DOMINION VIRGINIA POWER
NORTH ANNA UNIT 3 COMBINED LICENSE APPLICATION
SRP 3.3.1 AND 3.5.1.6: RESPONSE TO RAI LETTER 51

RAI 5138 Question 03.03.01-1

RAI 5214 Question 03.05.01.06-1

Figure 1: Location of Airports and Airways

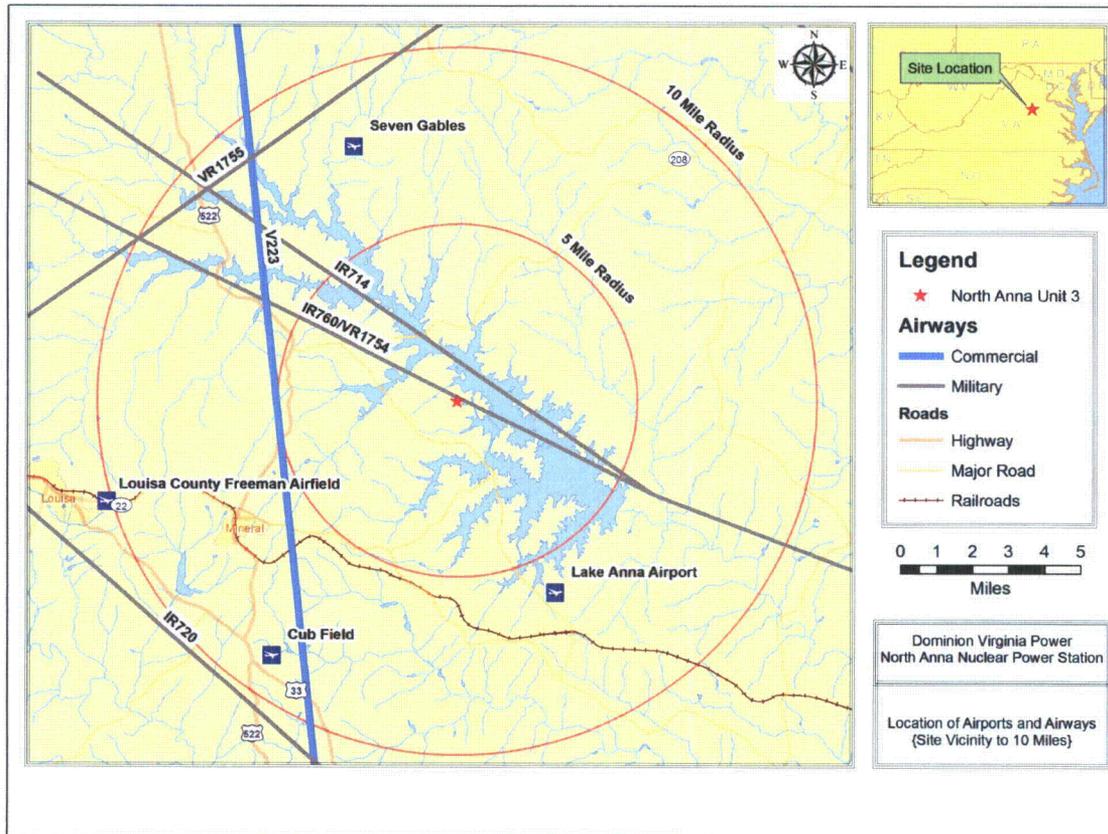
RG 1.206 provides guidance regarding the information that NRC needs to have reasonable assurance that potential hazards in the site vicinity are identified and evaluated, in accordance with the siting criteria in 10 CFR 100.20 and 10 CFR 100.21. In the North Anna Unit 3 COL FSAR, Section 3.5.1.6, the applicant reported aircraft impact probabilities from operations along civil airway V-223 and military routes IR714, IR760/VR1754, and VR1755. However, the applicant did not describe the effective area of the plant used in its calculation. Though the total probability calculated by the staff is on the order of 10^{-6} per year, the applicant concluded that the total probability is approximately 10^{-7} per year. The staff requests that the applicant explain its aircraft impact probability calculation in sufficient detail to allow an independent review, including a description of the effective area information assumed in its calculations.

The arrangement of each airway and location of Unit 3 are shown in Figure 1 below. Distances from the site to each airway were calculated and applied to this analysis. One commercial airway, V223, passes by the site. The width of a commercial airway is 8 nautical miles or 4 nautical miles on each side of the centerline. One nautical mile is equivalent to 1.15 statute miles; therefore, the corridors are 4.60 statute miles wide on each side of the centerline. Four military routes, IR714, IR 760/VR1754, IR720 and VR1755 pass by the site. The width of a military training route is 10 nautical miles (11.5 statute miles) or 5 nautical miles (5.75 statute miles) on each side of the centerline.

Airway	(1) Distance from Airway Centerline to the Site (mi)	(2) Width of Federal Airway each side of centerline (mi)	(3) Remaining Distance to the Site (mi)	(4) Width of Airway (w) (mi)
Commercial	V223	5	4.6	0.4	10
Military	VR1755	8.9	5.75	3.15	17.8
	IR720	10.2	5.75	4.45	20.4
	IR714	0.9	5.75	0	11.5
	IR760 / VR1754	0.1	5.75	0	11.5
